**Town of Rotterdam
Planning Commission
October 4, 2022**

DPW Comments
October 4, 2022

Re: *Site Plan Application – Proposed Key Bank*
1703 Altamont Avenue, Town of Rotterdam
CTMA Project No. 22.2224

Re: Site Plan Application - Proposed Key Bank
1703 Altamont Avenue, Town of Rotterdam
CTMA Project No. 22.2224
Response to Comments

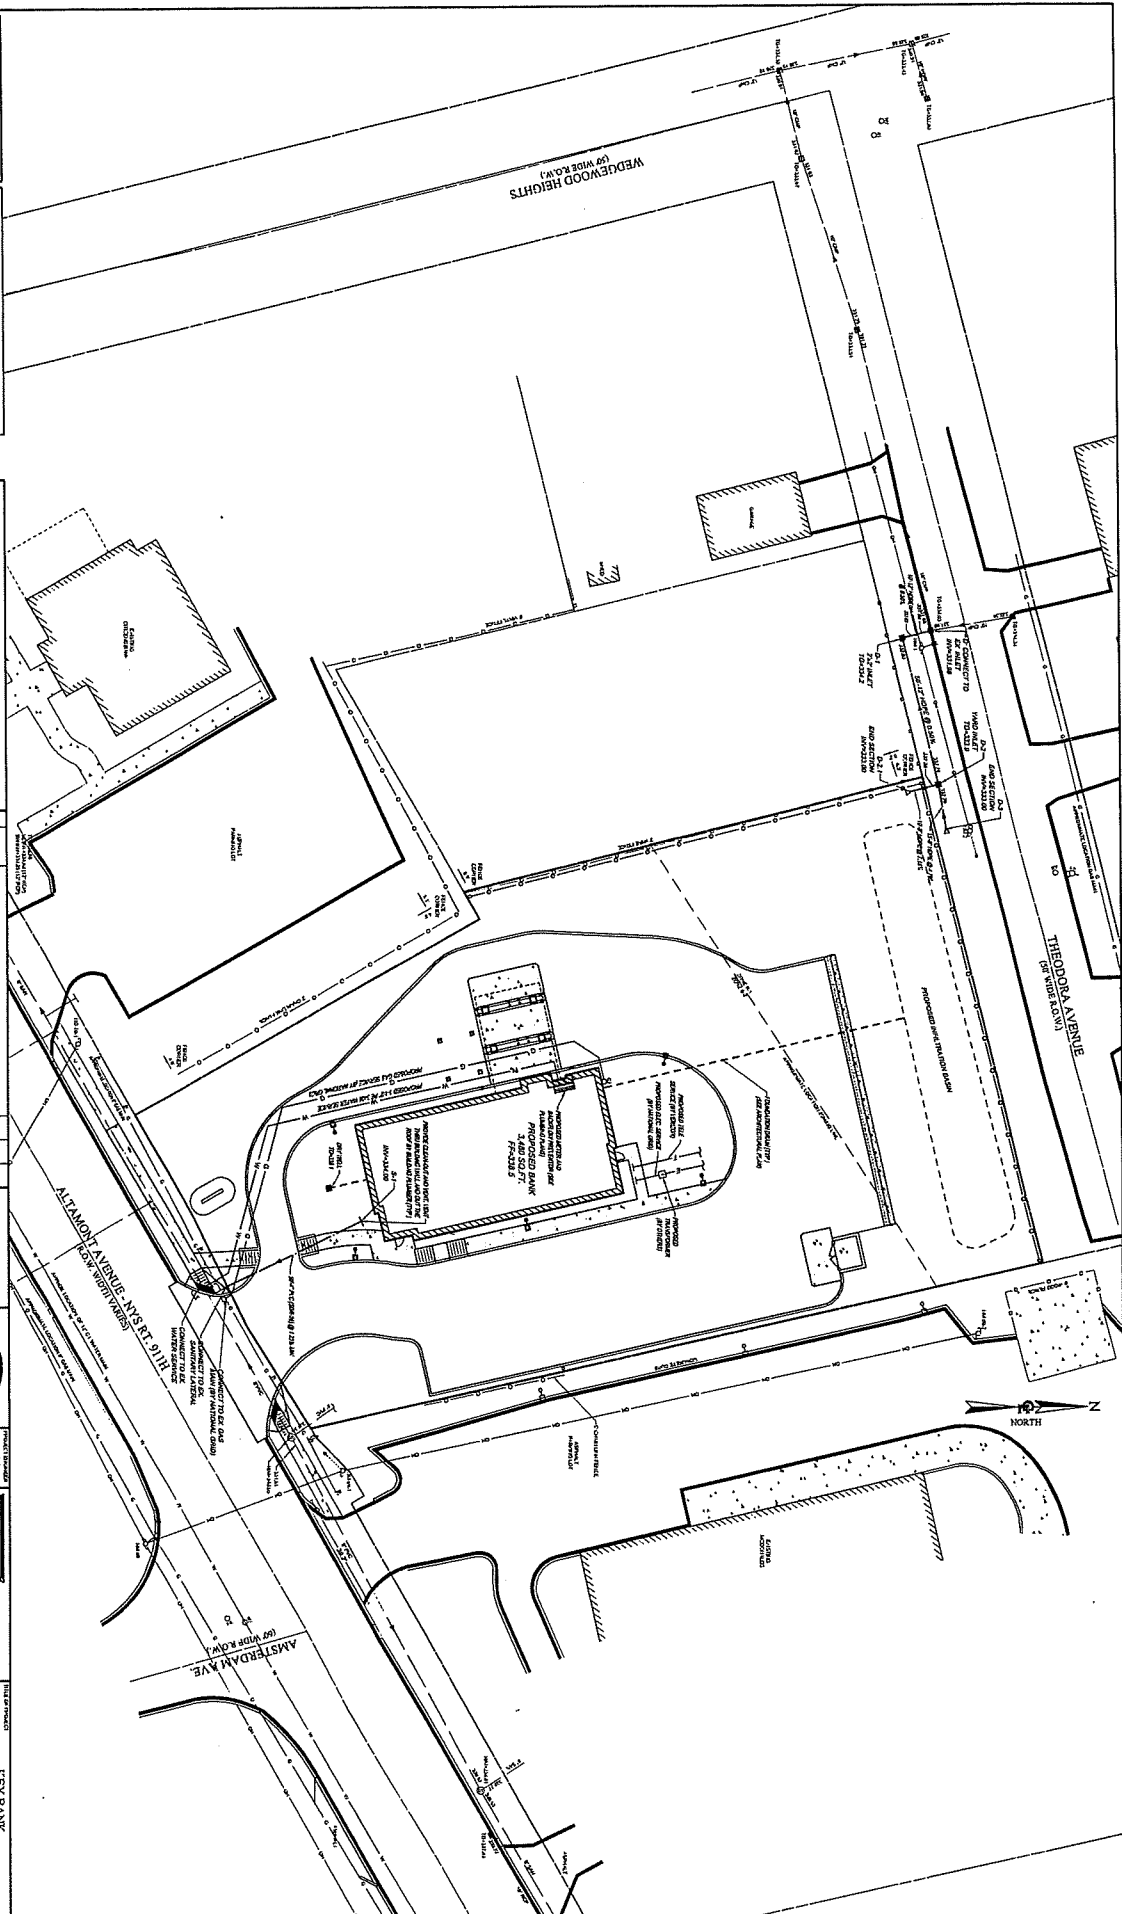
10. *We offer the following comments regarding Sheet "CA120" Utility Plan:*

- a. The applicant shall provide documentation that the proposed water and sanitary sewer and storm sewer connections have been coordinated with the appropriate Town Staff.*

- b. The proposed storm drainage pipes at the rear of the site along Theodora Avenue have minimal coverage. The design engineer shall provide documentation that the proposed pipes are designed to handle the minimal depths shown.*

Noted. Plans will be updated per any DPW comments received. Per conversation with Tammy from Town DPW, they concur with methods currently proposed.

See note #6 under "General Notes" on Drawing GA002.

TITLE OF PROJECT
 LANDSCAPE PLAN
 KEY BANK
 1703 ALTAIR AVENUE
 (CONTRACT NUMBER) EX-1000-00-001-011
 COUNTY OF ALBANY, STATE OF NEW YORK
 (OWNER) THE ALTAIR APARTMENTS AND SHOPPING
 CENTER, 1703 ALTAIR AVENUE, NEW YORK, N.Y. 10017
 (DATE) 10/10/00
 (DRAWN BY) J. L. LAIO

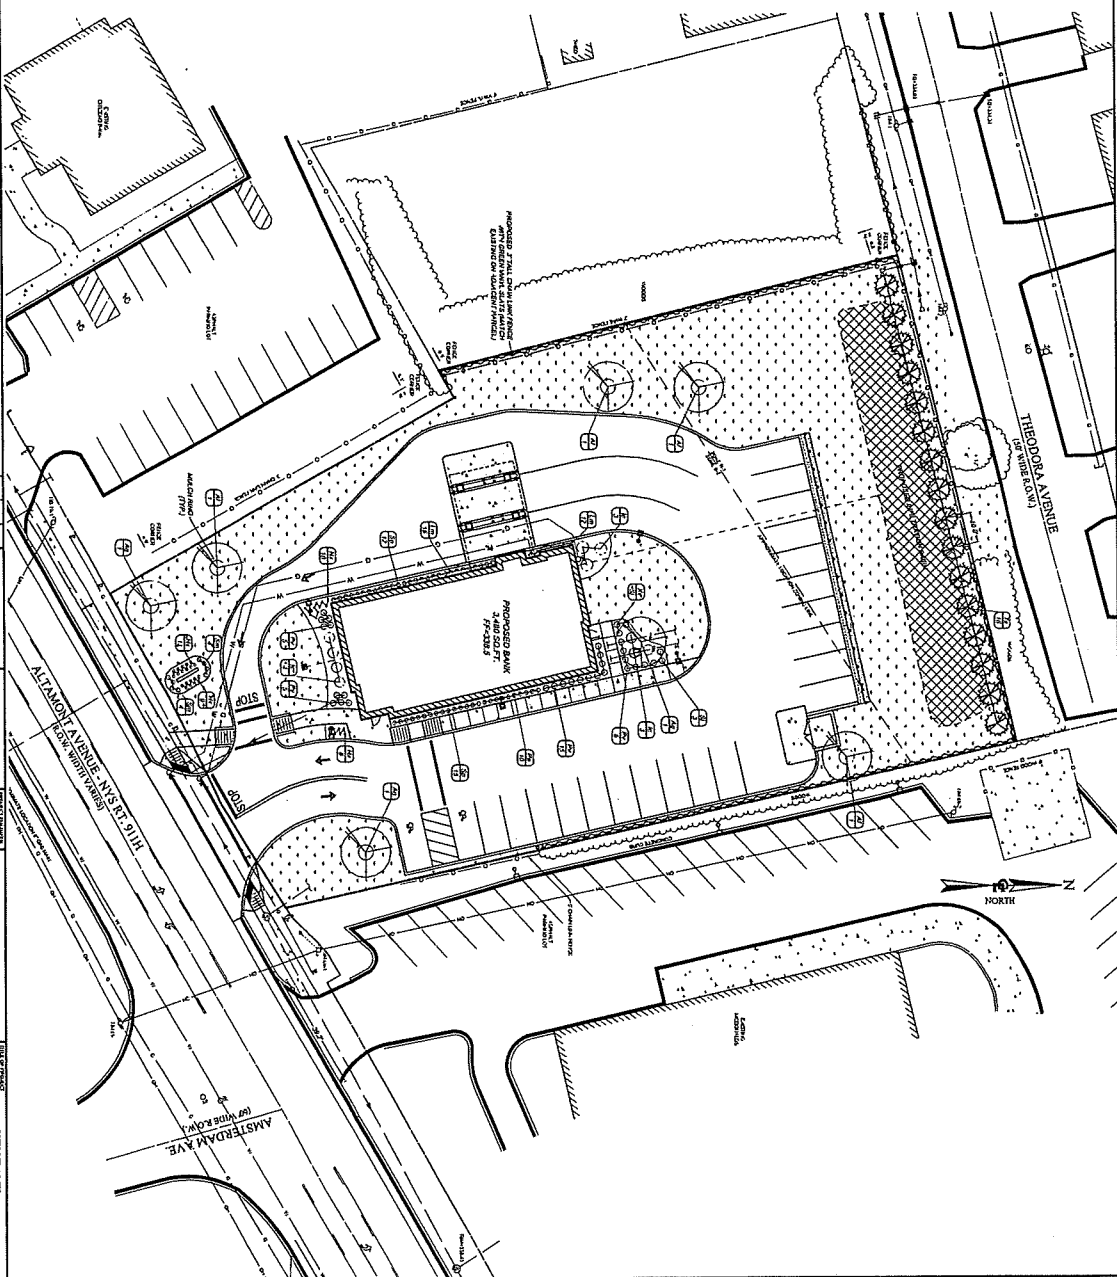
6. Add note to landscaping plans (LA100): "Landscaped areas located around the building shall contain an irrigation system which is maintained and operational."

7. Add note to landscaping plans (LA100): "All dead/dying landscaping materials shall be replaced in kind and maintained in perpetuity."
8. Curbing and sidewalk along Altamont Avenue should be replaced the entire length of the property and connect to existing sidewalks. Curb configuration still exists for prior buildings that have been demolished.

12. We offer the following comments regarding Sheet LA100 - Landscape Plan:
- a. *The ten (10) Douglas Fir are proposed for buffer screening to the adjacent residences to the north. We would recommend that Arbor Vitae trees spaced at 10' on center be used instead to provide more effective screening.*

- b. *Some exiting vegetation is proposed to be preserved along the proposed common property line to the west. However, the width is approximately 10 to 20 feet and the condition and type of the existing is unknown. Therefore, consideration should be given to installing privacy fencing or supplemental evergreen planting along the western property line to provide more effective screening, even during the "leaf off" winter season.*

- c. *Zoning section § 270-149, D. Off-street parking states Landscaping. Parking areas with than 12 spaces shall be landscaped over not less than 10% of the total interior area of the parking lot. Landscaping and planting areas shall be dispersed throughout the parking lot. Required screening and side yards may be considered as a part of the interior landscape requirement if suitably planted and maintained. The applicant shall document that the proposed design complies with this section.*

In lieu of additional plantings, we are proposing a 3' tall chainlink fence with green vinyl slats to match the Citizens Bank parcel to the west.

SD 1

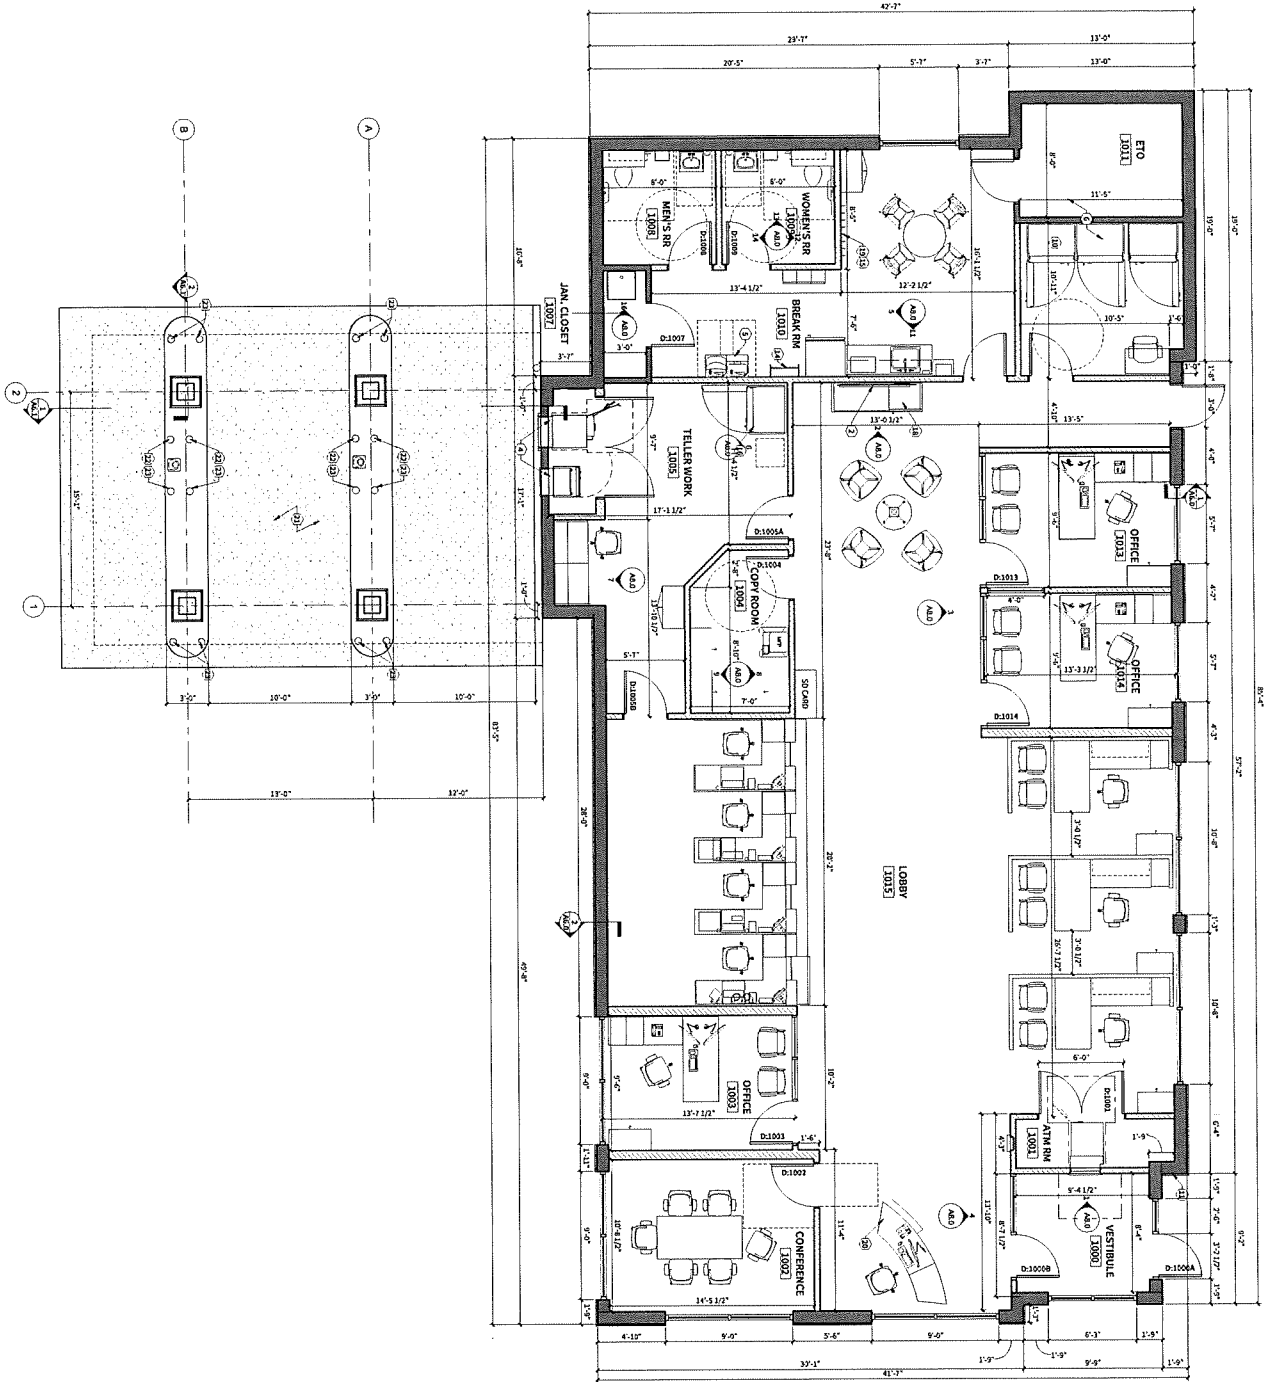
10. Add note to plan: “Building design shall be in substantial conformance to the proposed Exterior Elevations know as sheets SD1-SD4 entitled Rotterdam Branch Keybank National Association dated April 26, 2022 as prepared by HSB Architects & Engineers.”
